Title-Sujet Fort Malden Service Building Addition		Date February 7, 2017
Solicitation No. - No. de l'invitation 5P300-16-5678		Client Ref. No. – No. de réf du client.
GETS Reference No. – No de reference de SEAG		
Solicitation Closes L'invitation prend fin – at – à 2:00 PM on – le 2017-02-14		Time Zone Fuseau horaire - EASTERN STANDARD TIME (EST)
F.O.B. - F.A.B. Plant-Usine: <input type="checkbox"/> Destination: <input type="checkbox"/> Other-Autre: <input type="checkbox"/>		
Address Inquiries to: - Adresser toute demande de renseignements à : Sylvie Lagacé sylvie.lagace@pc.qc.ca		
Telephone No. - No de téléphone 418-648-5006		Fax No. – No de FAX: 418-649-6971
Destination of Goods, Services, and Construction: Destinations des biens, services et construction: See Herein		
Vendor/Firm Name and Address Raison sociale et adresse du fournisseur/de l'entrepreneur Telephone No. - No de telephone: _____ Facsimile No. - N° de télécopieur: _____

AMENDMENT #3

THE PURPOSE OF THIS AMENDMENT IS TO SHARE ANSWERS TO QUESTIONS 1 TO 17 ASKED BY POTENTIAL BIDDERS. THE INFORMATION MUST BE TAKEN INTO CONSIDERATION IN YOUR BID EVALUATION.

FORT MALDEN ADDITION

CSK-1

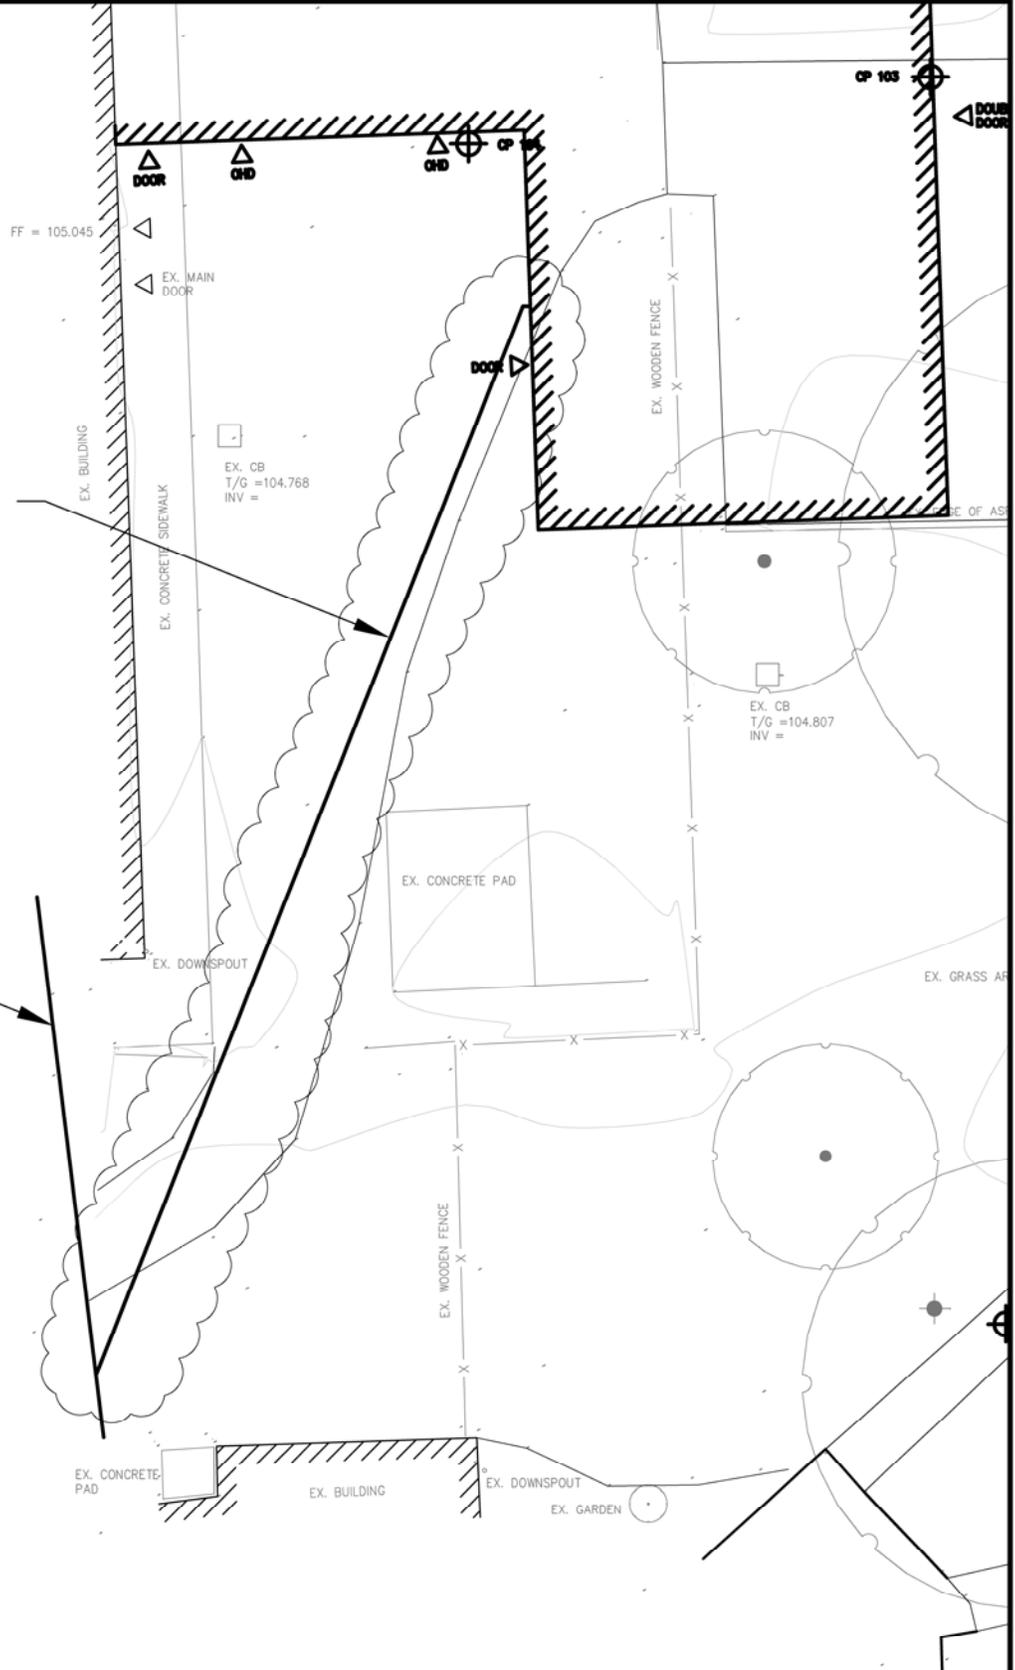
QUESTION 1.

How deep is the sanitary line as the depth is not indicated on the drawings?

See attached drawing " Fort-Malden - CSK1".

**NEW SANITARY LINE TO
 'Y' INTO EXISTING. DESIGN
 INVERTS TO BE PROVIDED
 PRIOR TO CONSTRUCTION.
 ASSUME DEPTH TO BE
 1525MM TO 1830MM.
 PROVIDE INSULATION FOR
 50% OF PIPE FROM NEW
 ADDITION**
